Council Meeting - Agenda Item 9.1- Attachment 7
Representations - 40 College Street Newstead - 1 July 2021

From: Jenni Healey
Sent: Sun, 25 Apr 2021 09:51:22 +1000
To: Contact Us
Subject: DA/0047/2021 - 40 College Street, Newstead
Attachments: 25042021093654-0001.pdf
Importance: High

DA0047/2021 – Residential – Construction of alterations and additions to a dwelling. 40 College Street, Newstead.

Sheet 16/17 “3pm 21 June Proposed and Existing” shows a significant increase in the shadow hitting the habitable rooms.

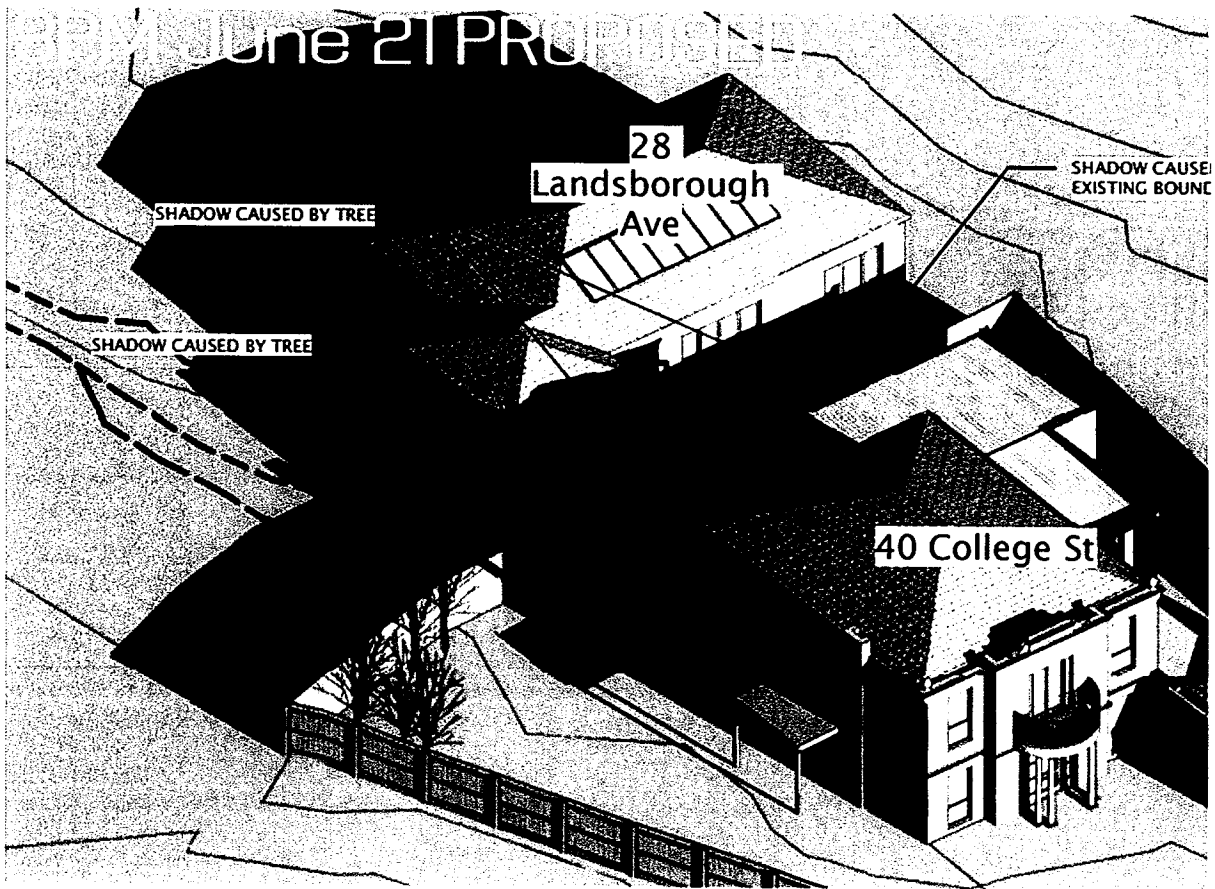
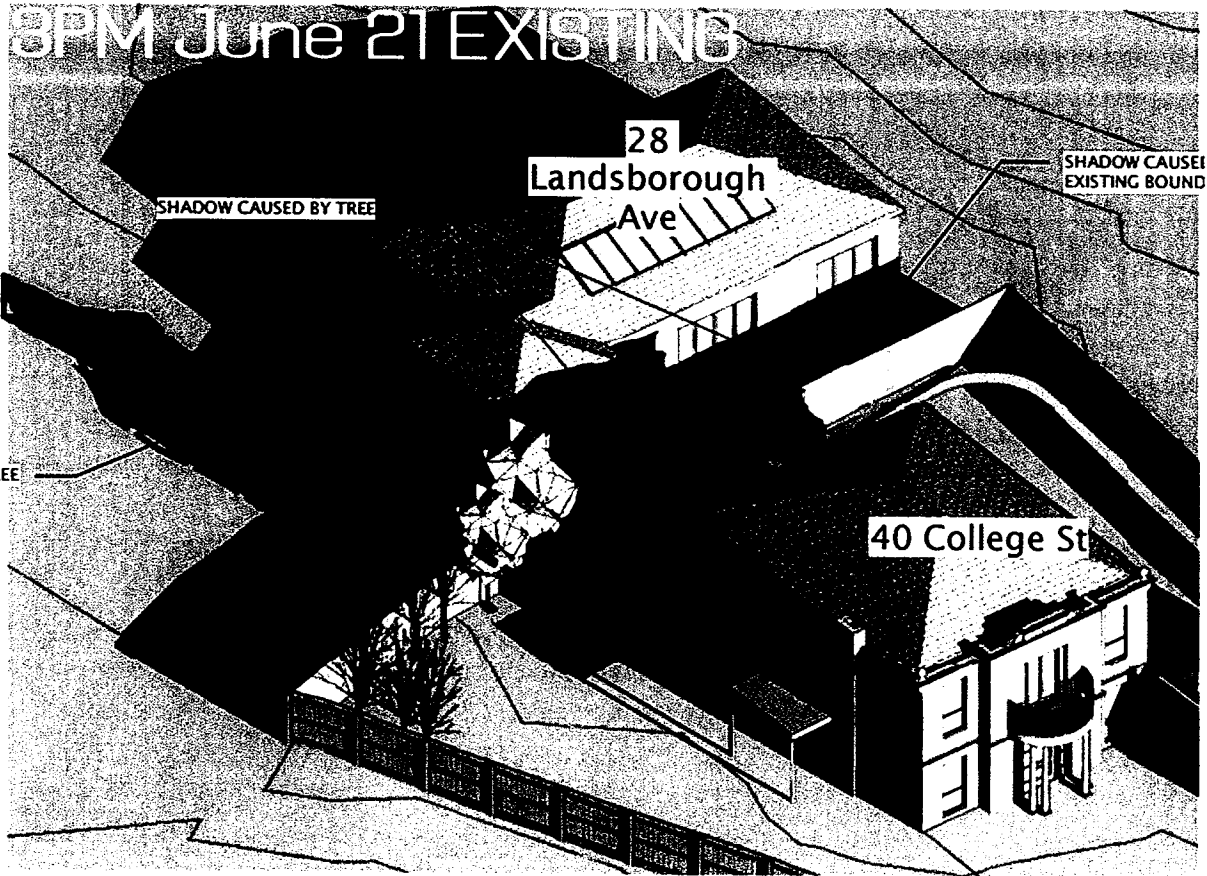
Drawings Taken from the Council Website – note shadow difference over patio doors.

As such the proposal fails to meet section b) of the Performance Criteria.

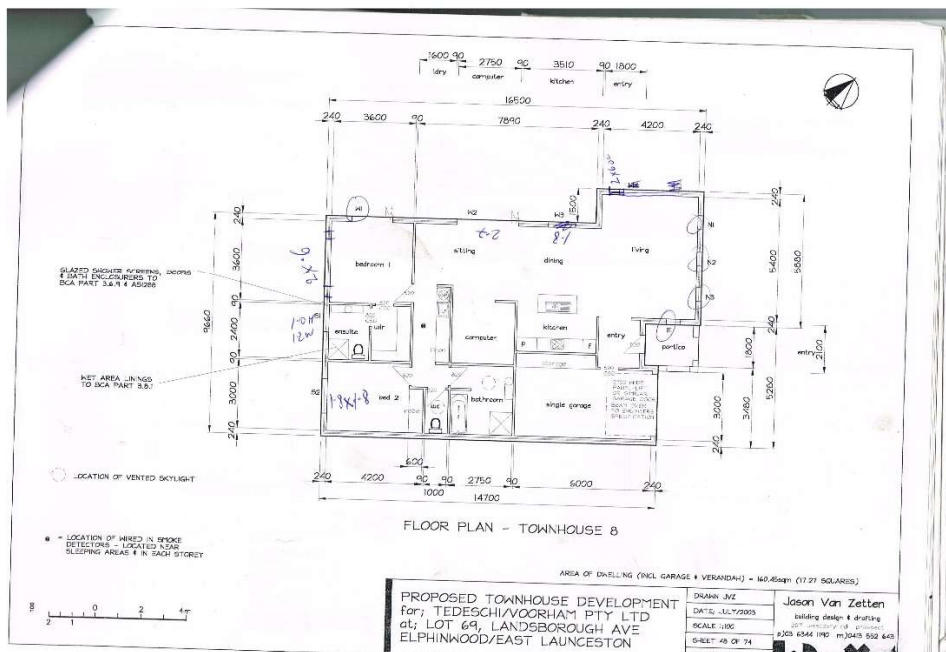
My elderly mother's private open space and living areas will be affected with a loss of amenity and reduced sunlight if council support this proposal, as per floor plan, all living and private open spaces face the north west directly at this proposal.
